Virgil C. Summer Nuclear Station (VCSNS) Units 2 and 3
Combined License Nos. NPF-93 and NPF-94
Docket Nos. 52-027 & 52-028

Subject: VCSNS Units 2 & 3 LAR 15-05: Request for License Amendment and
Exemption: Tier 1 Editorial and Consistency Changes

**License Amendment Request
Tier 1 Editorial and Consistency Changes
(LAR 15-05)**

Tier 1 Editorial and Consistency Changes

Tier 1 Figure 2.7.1-1 (Sheet 1 of 2); COL Appendix C, Figure 2.7.1-1 (Sheet 1 of 2)

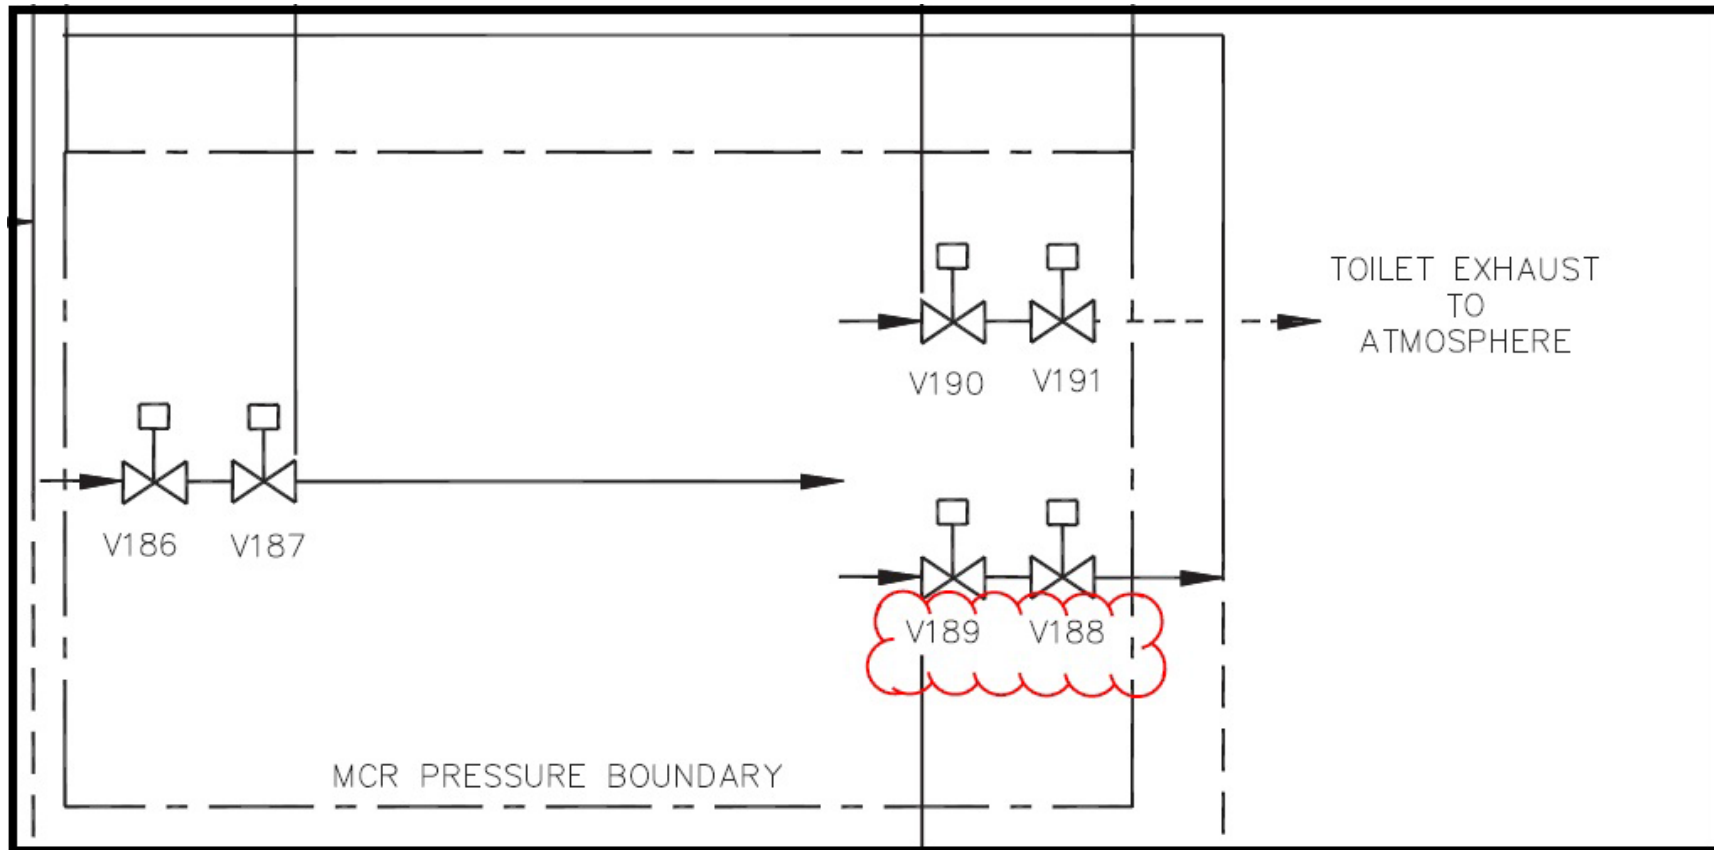
- h. Figure 2.7.1-1 – Tier 1 Figure 2.7.1-1, Sheet 1, illustrates the functional arrangement of the Nuclear Island Nonradioactive Ventilation System (VBS). Valves VBS-PL-V188 and VBS-PL-V189 are a pair of identical MCR Isolation Valves that perform the same design basis function and are of the same safety classification. This figure currently depicts valve VBS-PL-V188 as being upstream of valve VBS-PL-V189. However, the underlying UFSAR (plant-specific Tier 2) Figure 9.4.1-1 (Sheet 5 of 7) illustrates the opposite, that VBS-PL-V189 is upstream of VBS- PL-V188. Additionally, the underlying AP1000 design documentation in effect at the time of DCD certification and the current design documentation further identify that VBS-PL-V189 is upstream of valve VBS-PL-V188. Thus, a change is proposed to revise the tag numbers in COL Appendix C (and plant-specific Tier 1) Figure 2.7.1-1 to depict VBS-PL-V189 upstream of VBS-PL-V188 for consistency with the underlying UFSAR detailed information and the underlying system design.

- Tier 1 Figure 2.7.1-1 (Sheet 1 of 2)
 - Revise to depict valve VBS-PL-V189 as upstream of valve VBS-PL-V188.
- Tier 1 Table 3.2-1
 - Revise to eliminate the inconsistent reference to the acceptance criteria of design commitment 3 within 1.b of the Acceptance Criteria.

Item h: Revise to depict valve VBS-PL-V189 as upstream of valve VBS-PL-V188.
